Re: S/D 88-55 - Chaos Addition

EXHIBIT "A" - S/D 88-55
CHAOS ADDITION, FINAL PLAT
STAFF COMMENTS APPROVED BY S/D COMMITTEE 7/28/88

STAFF REPORT
(Final Plat; Preliminary Approved: July 7, 1988)

STAFF REPORT
(Preliminary Plat)

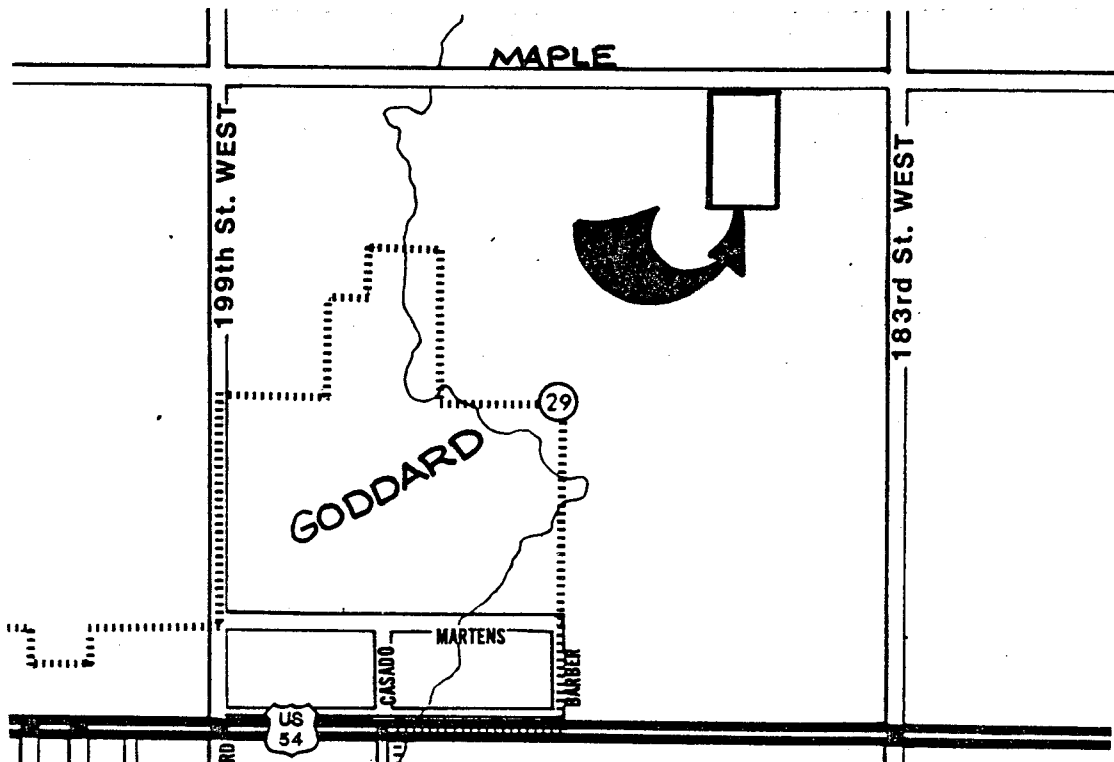
- A. Since neither municipal water nor sanitary sewer is available to serve this property, the applicant shall contact the Environmental Health Division of the Health Department to find out what tests may be necessary and what standards are to be met for approval of on-site sewerage facilities and water wells. A memorandum shall be obtained specifying approval.

- B. The applicant shall guarantee any drainage improvements required by the platting of this property.
- C. If improvements are guaranteed by petition, a notarized certificate listing the petitions shall be submitted to the Planning Department for recording.

- D. Approval of this plat will require a waiver of the lot depth to width ratio of the Subdivision Regulations. The Subdivision Regulations state that, "the maximum depth of all residential lots shall not exceed $2\frac{1}{2}$ times the width thereof." The present plat shows a ratio of approximately 4:1.

- E. To receive mail delivery without delay, and to avoid unnecessary expense, the applicant is advised of the necessity to meet with the U.S. Postal Service Growth Management Coordinator (phone 316-946-4527) prior to development of the plat so that the type of delivery, and the tentative mailbox locations can be determined.

- F. The applicant's engineer is advised that the Register of Deeds is requiring the name(s) of the notary public, who acknowledges the signatures on this plat, to be printed beneath the notary's signature.

- G. The applicant shall install or guarantee the installation of all utilities and facilities which are applicable and described in Article 8 of the MAPC Subdivision Regulations.

- H. Requirements for a final plat (see pages 20-25, Part 4, Article 5 of the MAPC Subdivision Regulations).
- I. Perimeter closure computations shall be submitted with the final plat tracing. Section 5-101(C).

- J. Recording of the plat within 30 days after approval by the City Council.
- K. The representative from the County Engineer's office should be prepared to comment on the status of the applicant's drainage plan. Specifically, are any drainage improvements required?

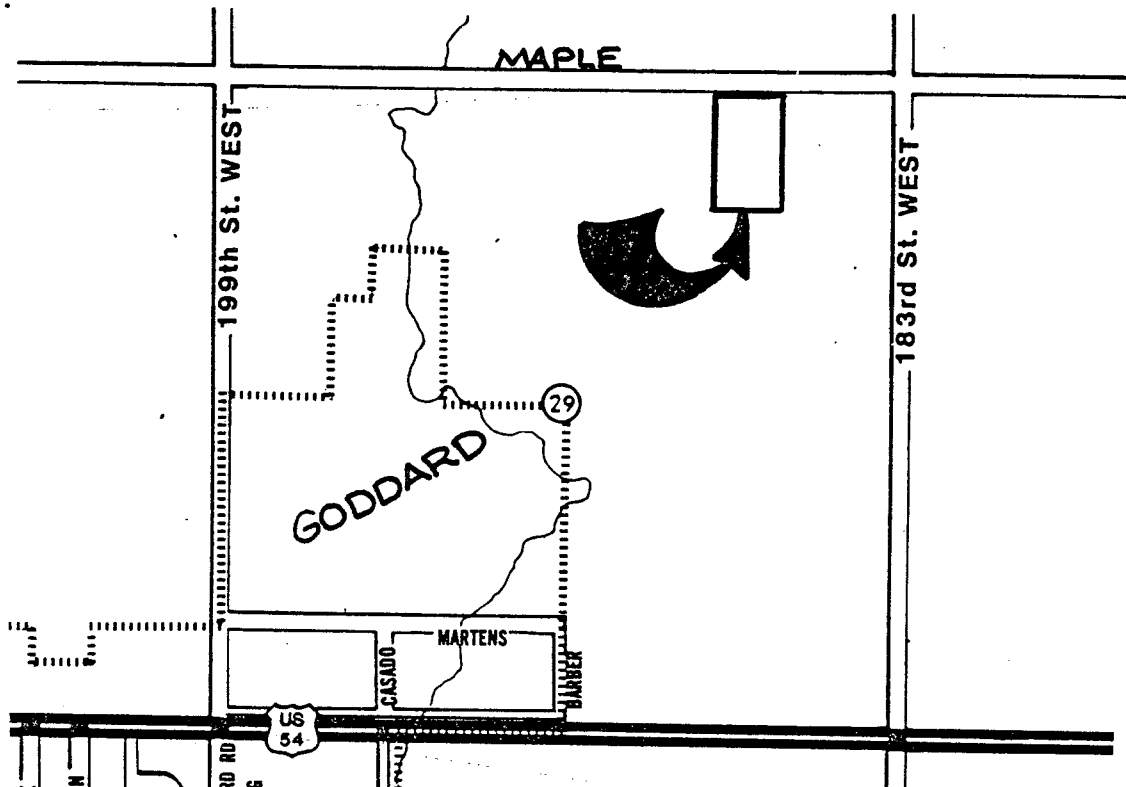
- A. Since neither municipal water nor sanitary sewer is available to serve this property, the applicant shall contact the Environmental Health Division of the Health Department to find out what tests may be necessary and what standards are to be met for approval of on-site sewerage facilities and water wells. A memorandum shall be obtained specifying approval.

- B. The applicant shall guarantee any drainage improvements required by the platting of this property.
- C. If improvements are guaranteed by petition, a notarized certificate listing the petitions shall be submitted to the Planning Department for recording.

- D. The final plat shall indicate the amount of half-street right-of-way adjacent to the plat as well as the amount of additional right-of-way being dedicated by this plat for 6th Street South.

- E. The final plat shall indicate the platting of "access control except for one opening per lot" to 6th Street across the north line of Lots 1 and 2.

- F. The platting text shall also reference the platting of access control to 6th Street and shall indicate that the access control is being dedicated to the County and that the location of permitted openings shall be determined by the County Engineer.

- G. Approval of this plat will require a waiver of the lot depth to width ratio of the Subdivision Regulations. The Subdivision Regulations state that, "the maximum depth of all residential lots shall not exceed $2\frac{1}{2}$ times the width thereof." The present plat shows a ratio of approximately 4:1.

- H. As required by Section 8-103(I), the final plat tracing shall indicate the placement of irons at all corners of this subdivision. A legend shall be added to the face of the plat which identifies the irons set and the irons found.

- I. To receive mail delivery without delay, and to avoid unnecessary expense, the applicant is advised of the necessity to meet with the U.S. Postal Service Growth Management Coordinator (phone 316-946-4527) prior to development of the plat so that the type of delivery, and the tentative mailbox locations can be determined.

- J. The applicant's engineer is advised that the Register of Deeds is requiring the name(s) of the notary public, who acknowledges the signatures on this plat, to be printed beneath the notary's signature.

- K. The applicant shall install or guarantee the installation of all utilities and facilities which are applicable and described in Article 8 of the MAPC Subdivision Regulations.

- L. Requirements for a final plat (see pages 20-25, Part 4, Article 5 of the MAPC Subdivision Regulations).
- M. The representatives from the utility companies should be prepared to comment on the need for utility easements to be platted on this property.

- N. The representative from County Engineering should be prepared to comment on the status of the applicant's drainage concept.
